Addendum #6

Bid Opportunity: 831-2024 - 32-Unit Affordable Housing Apartment Building

INTERIOR WINDOWS

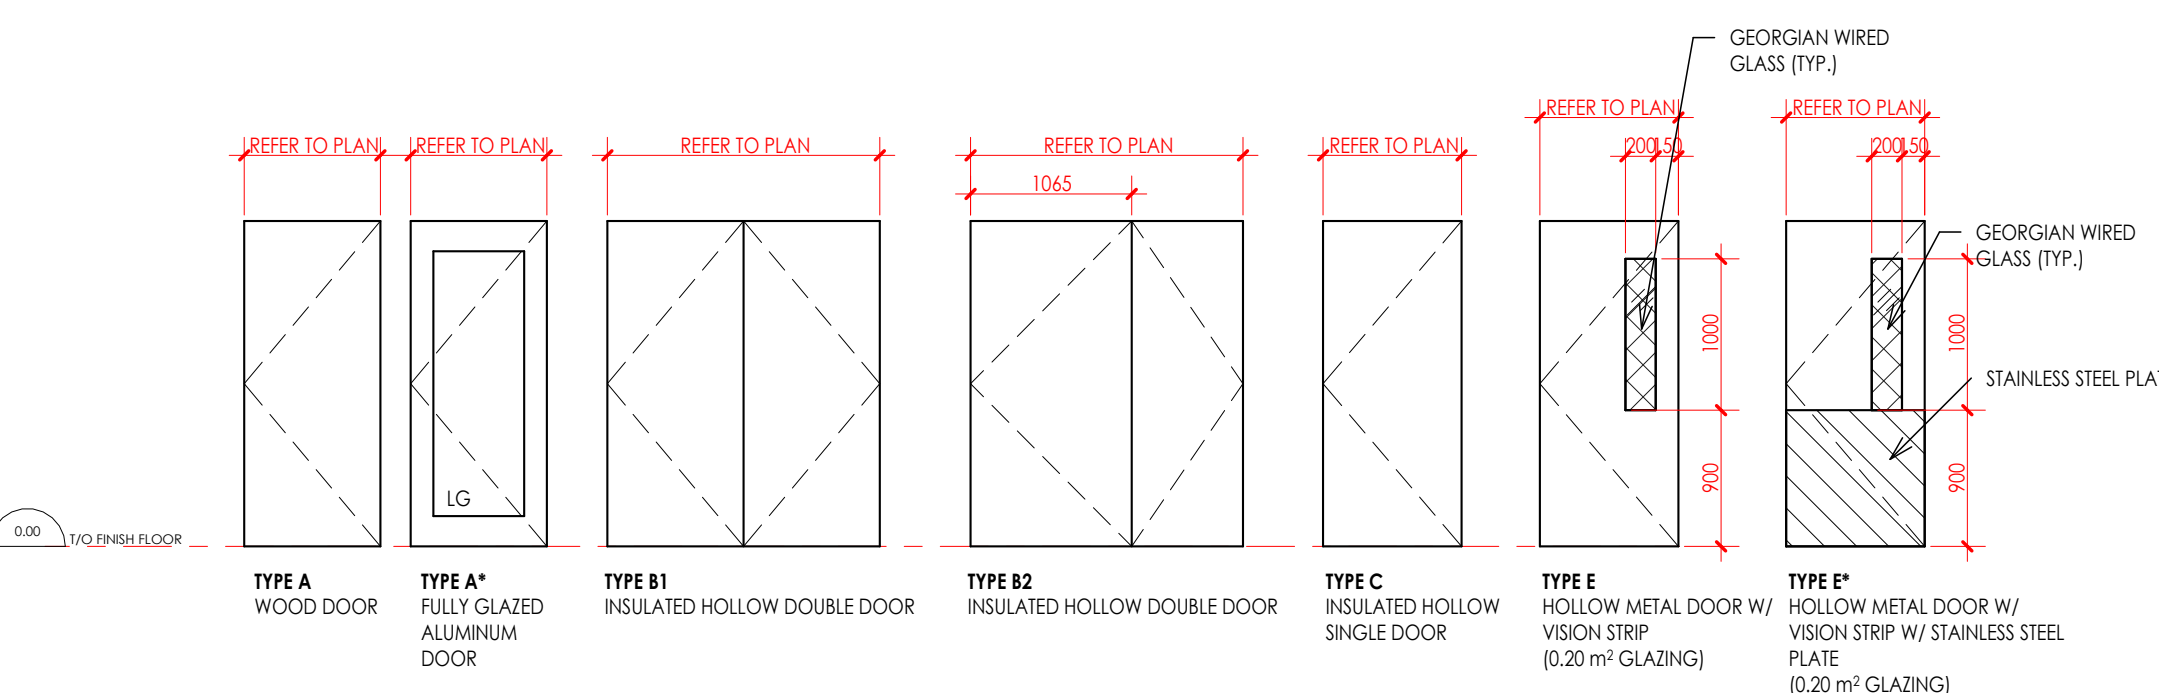
Interior windows IG109; IG110; IG213A; IG213B; IG313A; IG313B are those windows hollow metal?

These windows are to be fire rated hollow metal frames.

2 DOOR TYPES
A004 1 : 50

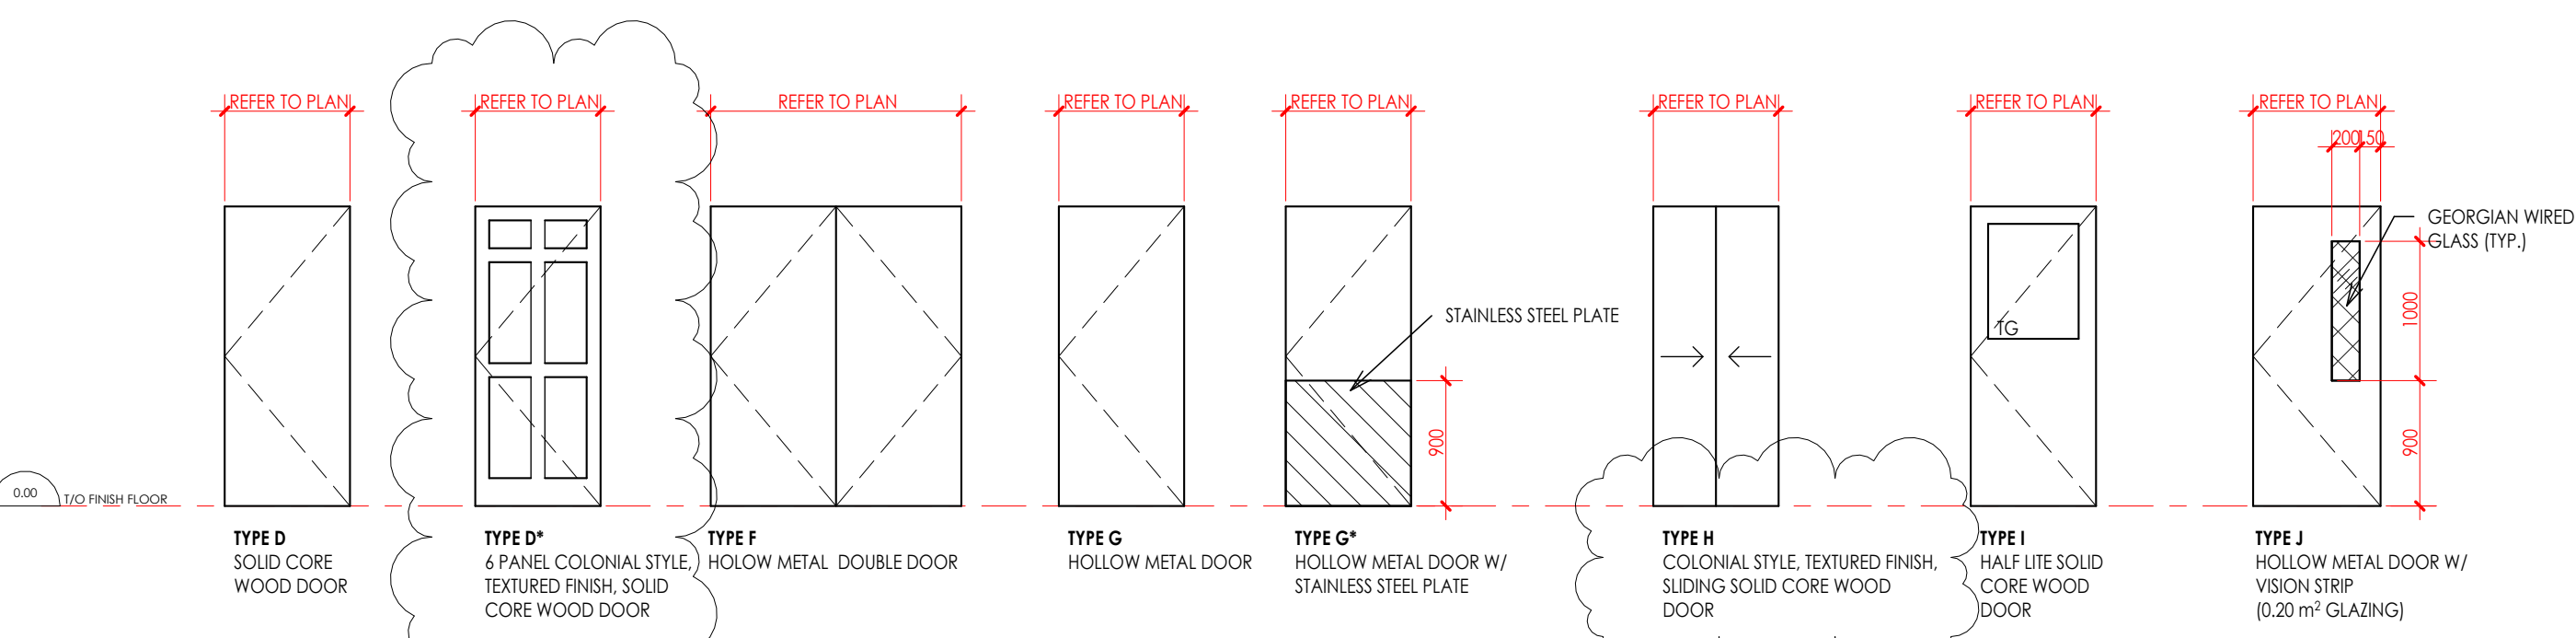
Interior Suite Doors:

On sheet A004, the schedule tables indicate door type "D" for various interior doors. These doors inside the suites are NOT to be smooth finish: they are to be 6-panel colonial style, textured "wood-grain" finish, painted. New door type "D*" has been added. Other updates are also included, as referenced later in this addendum.

Insert: A004 – Door Schedule – Units Window Type Schedule", issued for ADD04, 2024 10 18
